A G E N D A

Architectural Review Board

September 26, 2017

1603/1605 Madison Avenue

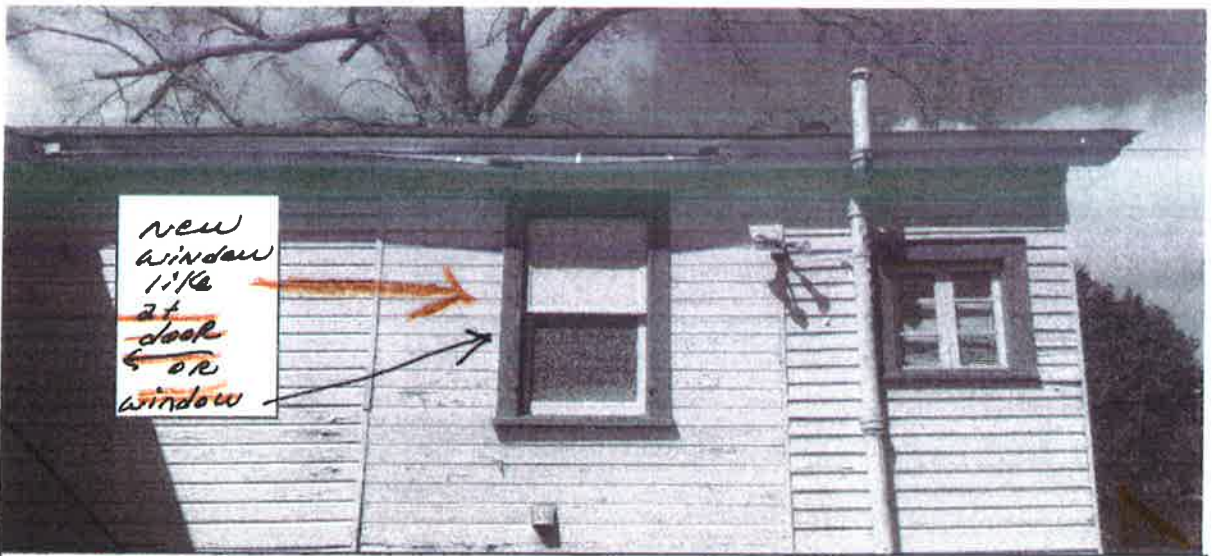
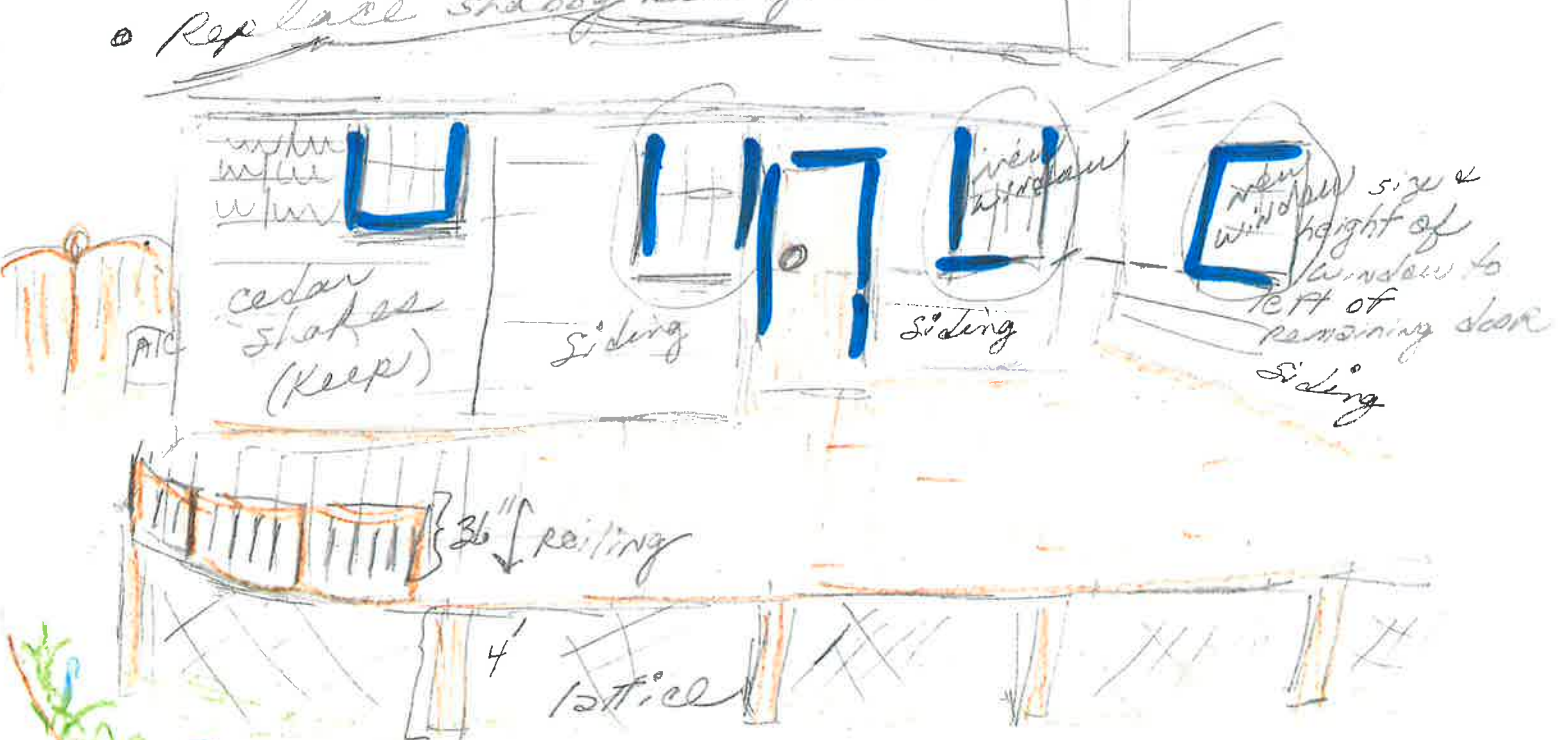
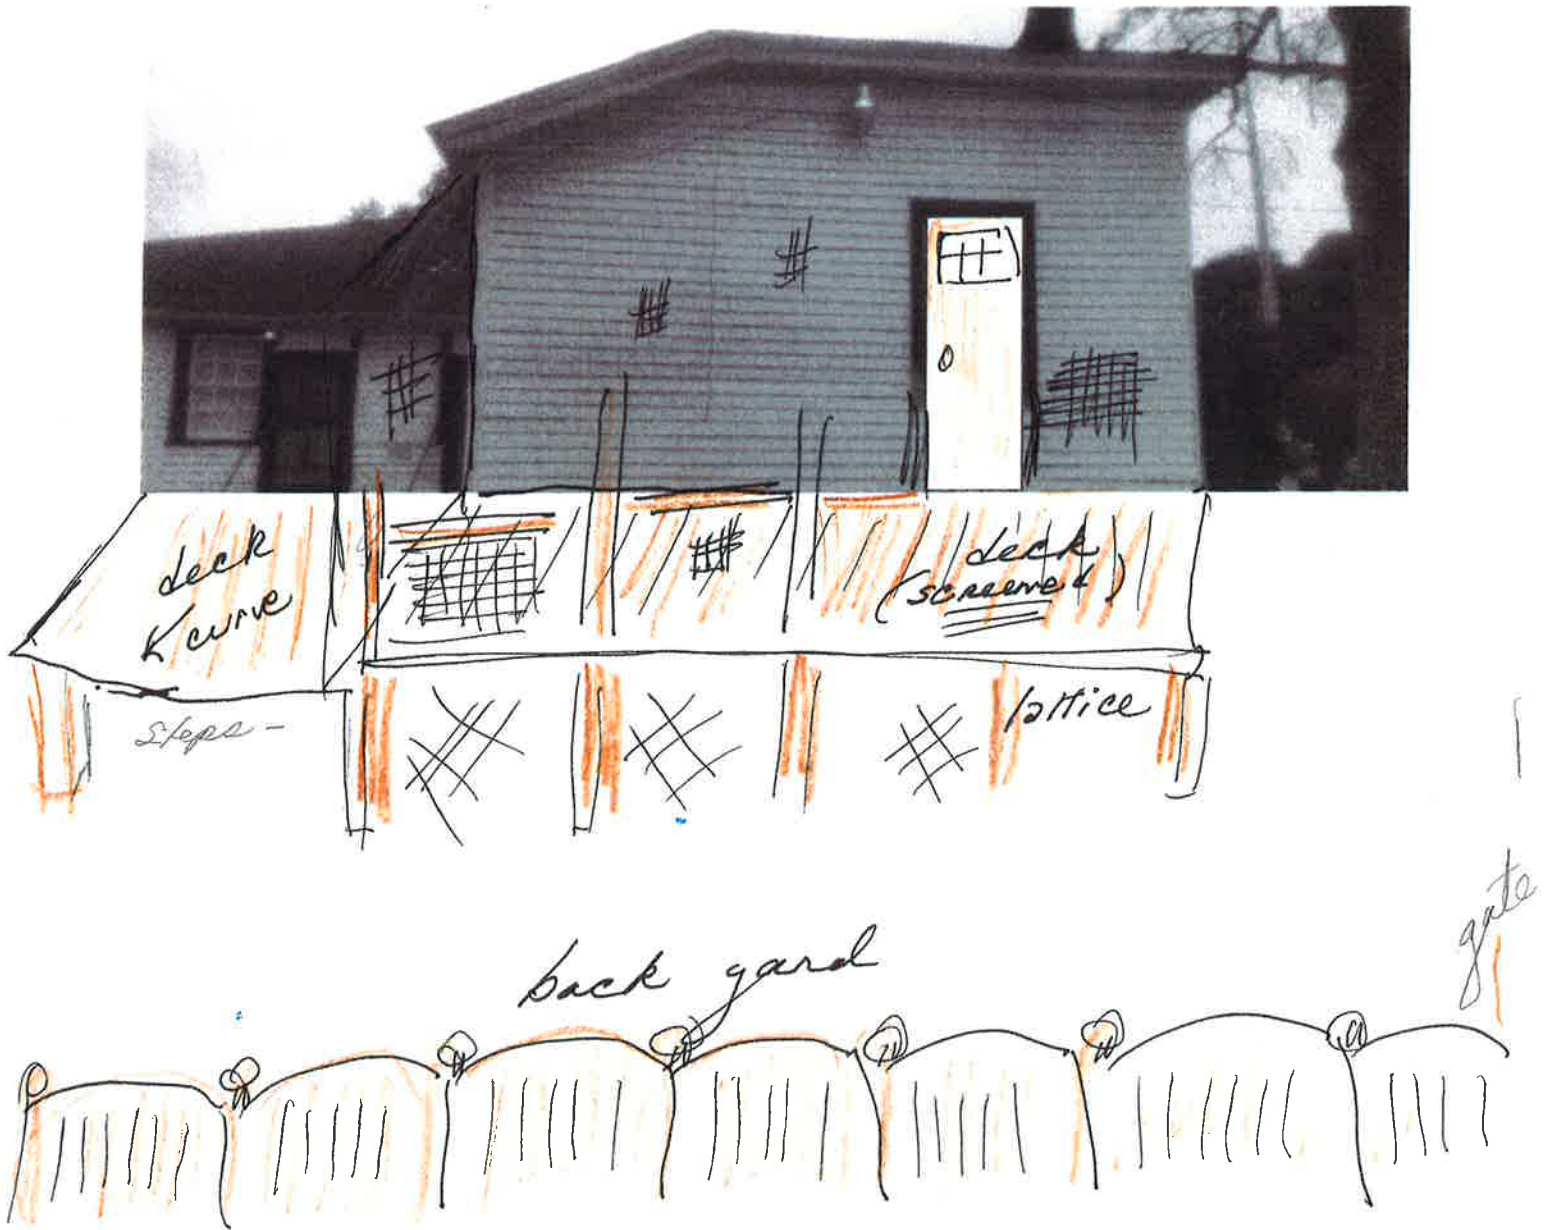
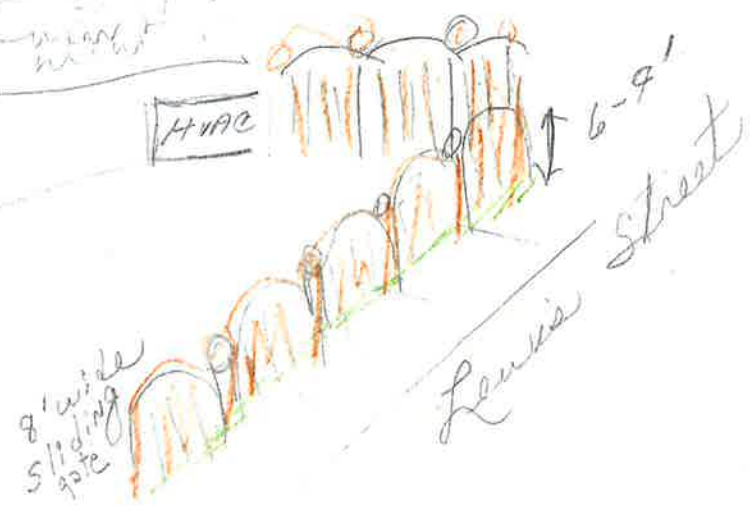
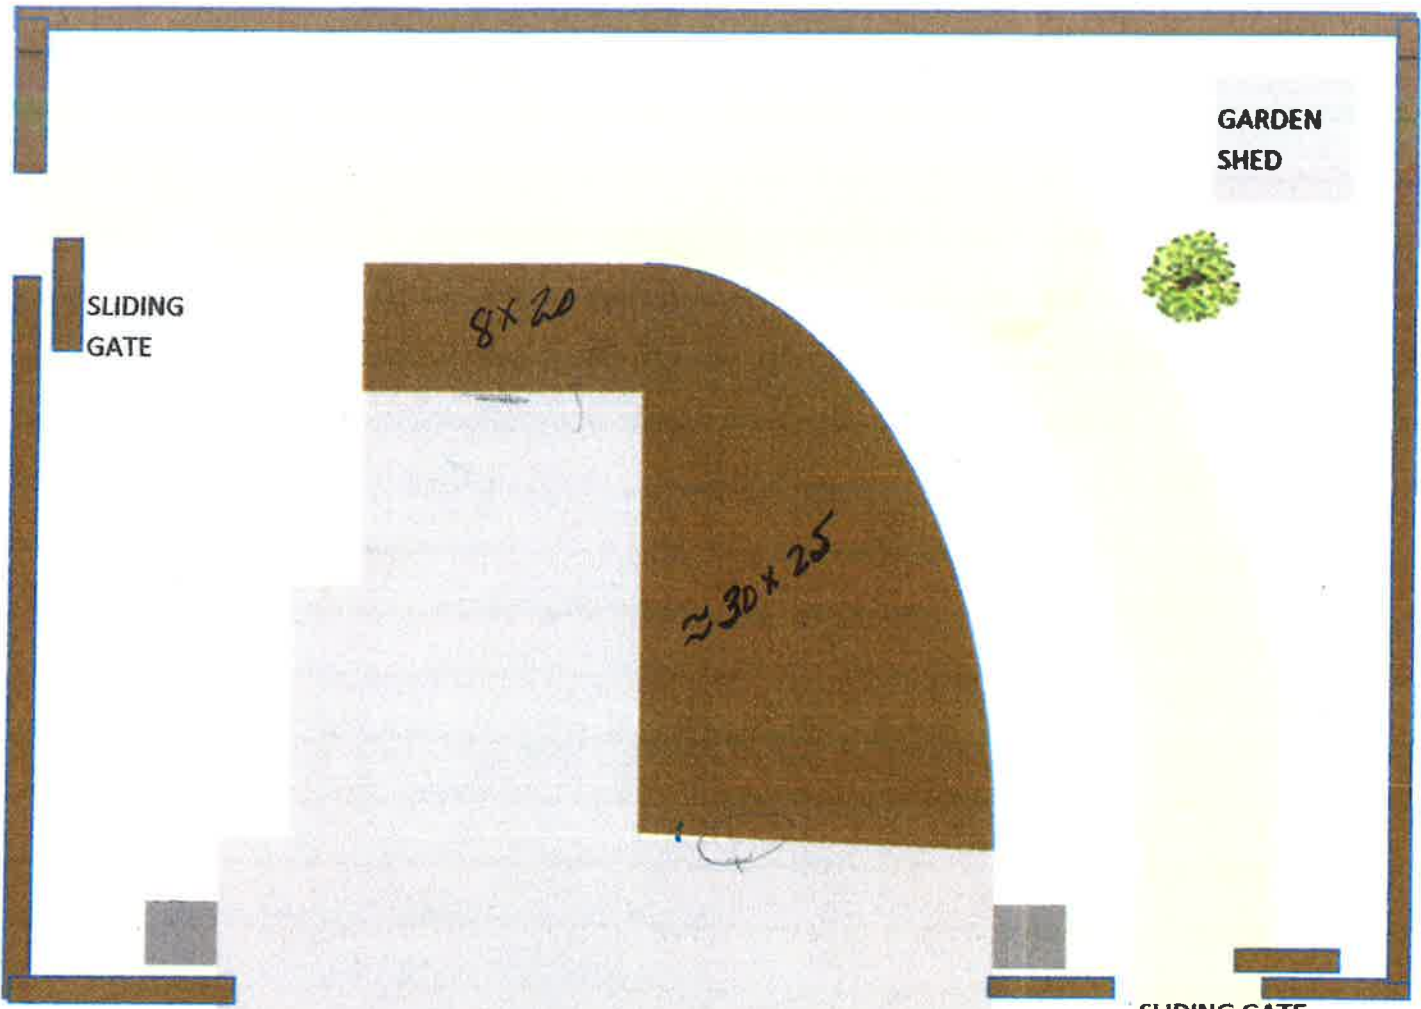
- The petitioner has been advised that better drawings for the screen porch portion of the project may be required before the Board can approve it. The Board may consider approving the deck (since it relates to a proposed door), and delay a decision on the enclosure subject to receiving additional materials to review.
- A concrete apron is required from the street to the back of the sidewalk to contain gravel.

- The petitioner indicated that the windows would be wood true divided lite windows—if there is any modification to that plan, the windows would be subject to re-review for materials.
- There are images of sheds attached, but no details relating to wall height, roof pitch, eave overhangs, etc. The Board is reminded that it is not up to you to design the building for the petitioner.
